10/604,555

Office Action Summary

DETAILED ACTION

FIG. 4

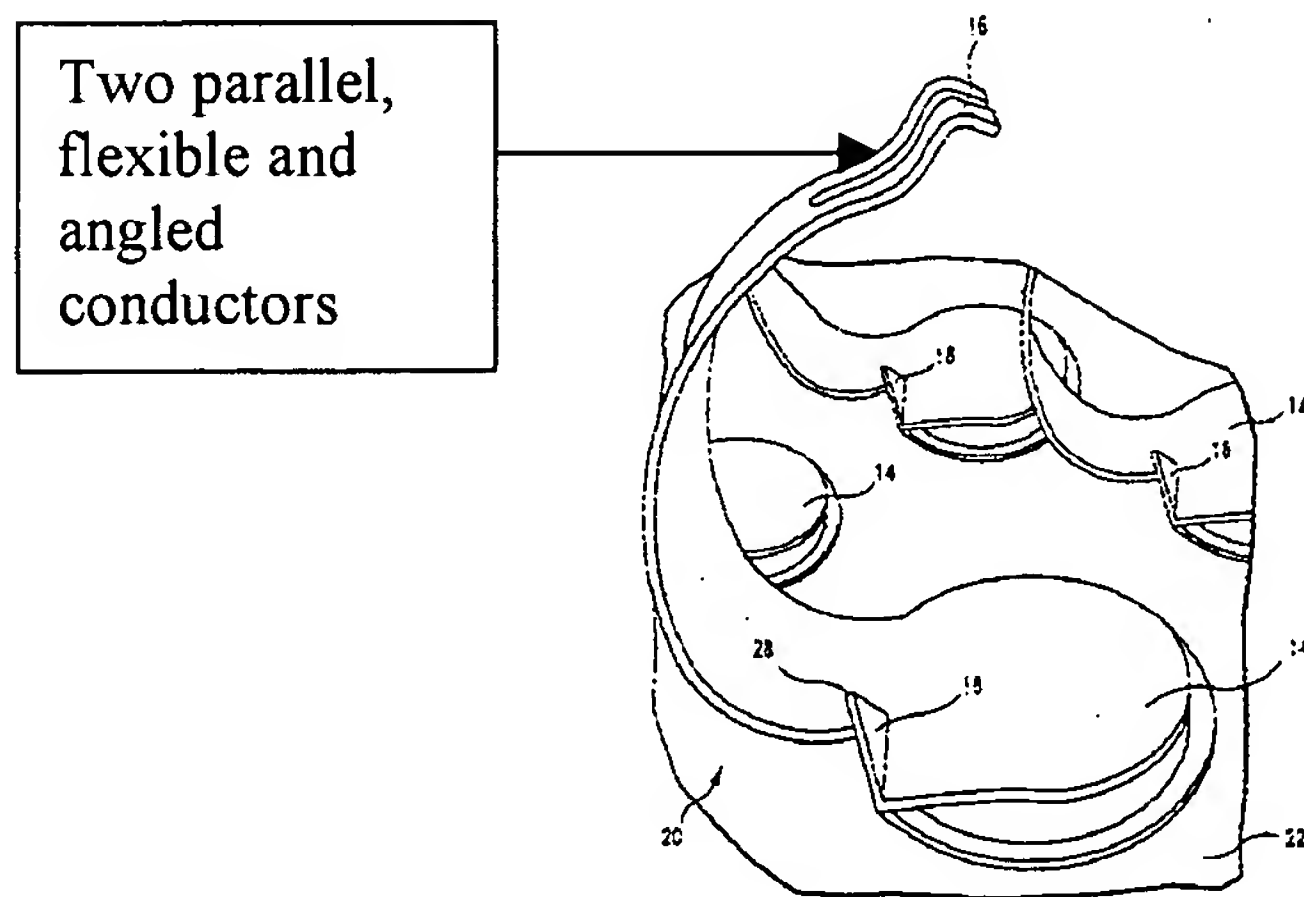
Guerin discloses an assembly of an integrated circuit (IC) package comprising a plurality of input/output (I/O) pads 34 on a surface of the IC package 32, a plurality of contact pads 26 on a substrate 22, and a plurality of electrically conductive connectors 12. Each of the connectors 12 comprises a first contact surface 16, a second contact surface 14 with a tab 18, and a flexible portion interconnecting the first and second contact surfaces 16 and 14. The first contact surface 16 of the connectors 12 is joined to an I/O pad 34 of the IC package 32 and the second contact surface 14 of the connectors 12 is joined to a contact pad 26 on the substrate 22 by solder. Each of the flexible portions is comprised of at least two parallel, angled and flexible conductors, wherein the conductors are electrically insulated from each other for a portion of their lengths.
